**STATE 6 NYCRR PART 373 PERMIT
PERMIT MODIFICATION
FACT SHEET
FOR
CWM CHEMICAL SERVICES, LLC
MODEL CITY, NEW YORK
NIAGARA COUNTY
EPA ID. No: NYD049836679
NEW YORK STATE DEPARTMENT OF ENVIRONMENTAL CONSERVATION**

CWM has submitted the following three (3) Permit modification applications:

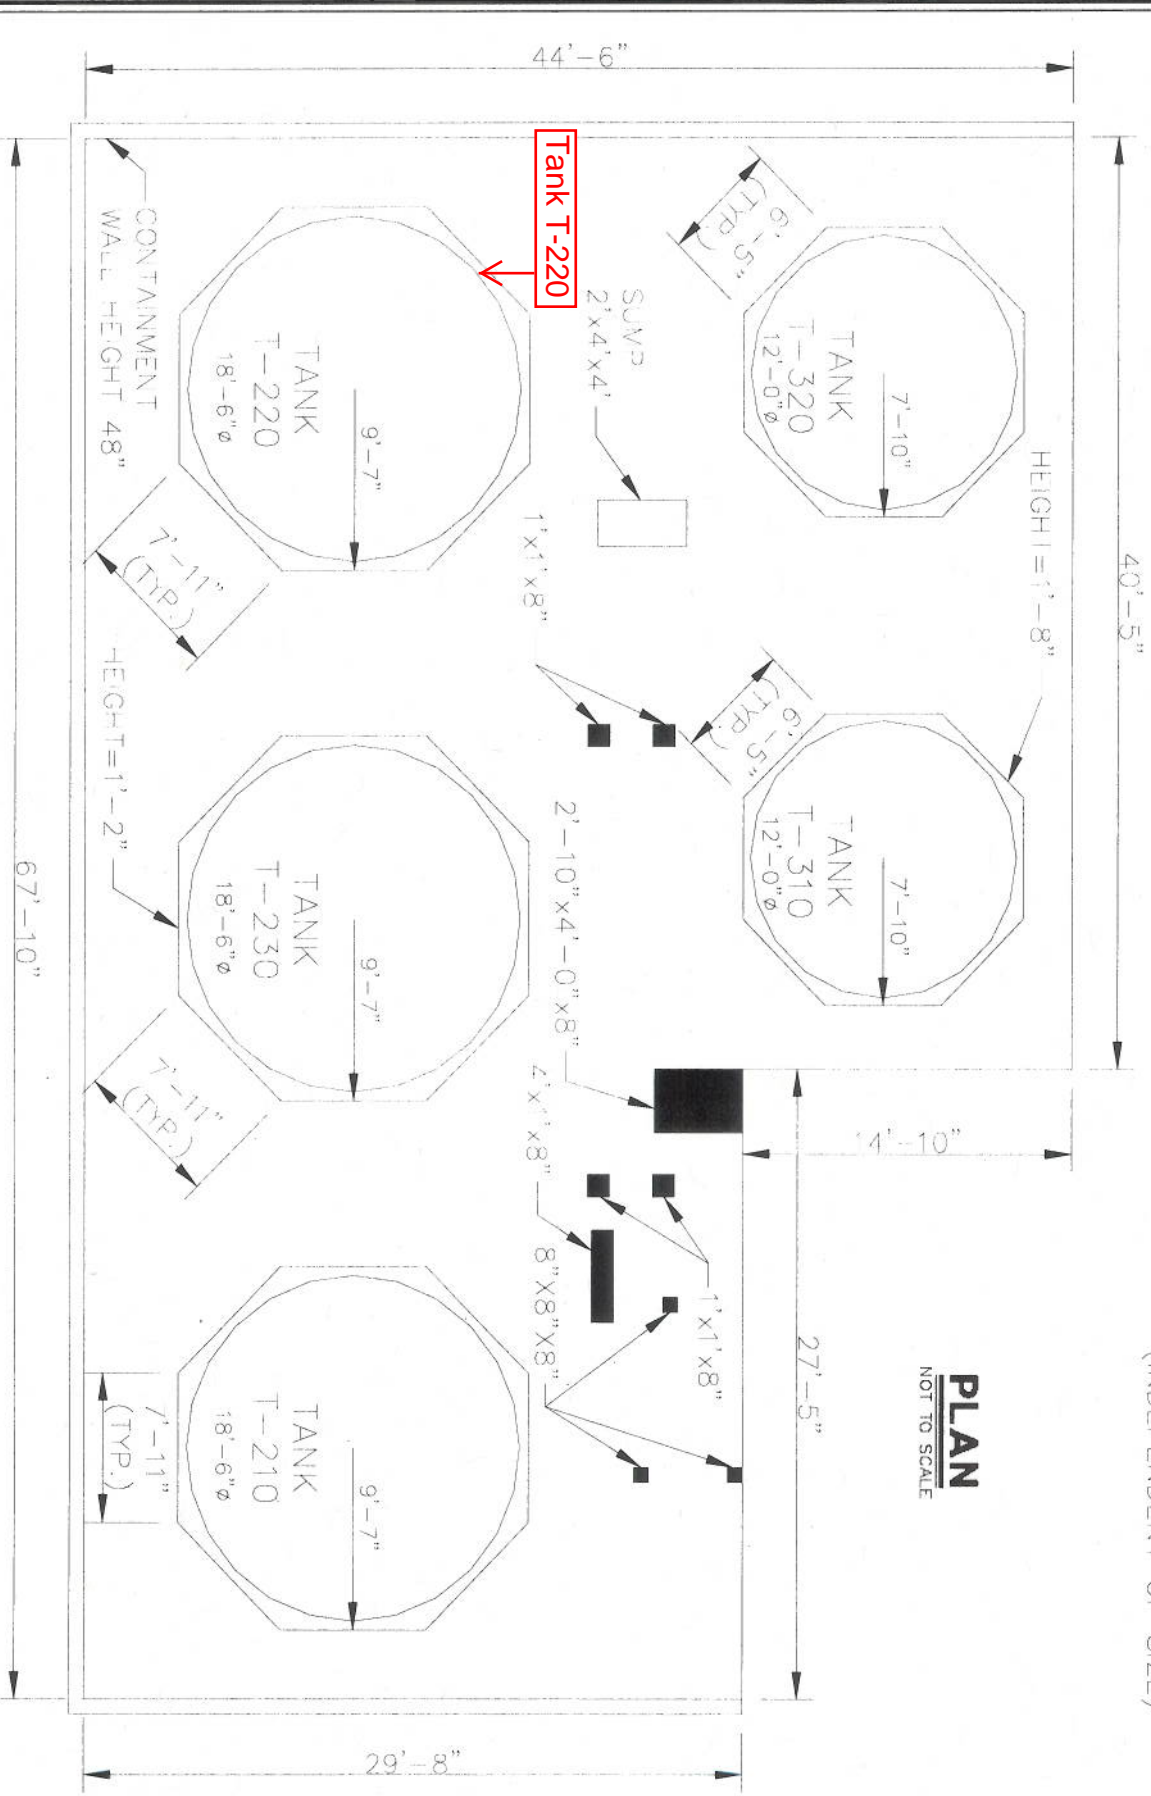
Tank T-165 consists of a new circular, Glass Fused Steel (GFS) tank which is approximately 70 feet in diameter by 31 feet high on a coated concrete foundation. It is an open top tank with a designed capacity of 876,800 gallons. Required secondary containment for this tank would be provided by a circular vault consisting of a coated concrete base and GFS walls, which is designed to hold greater than 100% of the tank's capacity. Both the tank and the secondary containment walls would be assembled on-site by bolting and sealing GFS panels together. The Tank T-165 system would also include leak detection channels under the tank, as well as pumps, piping and other miscellaneous equipment. A sketch of the Tank T-165 system is attached to this Fact Sheet.
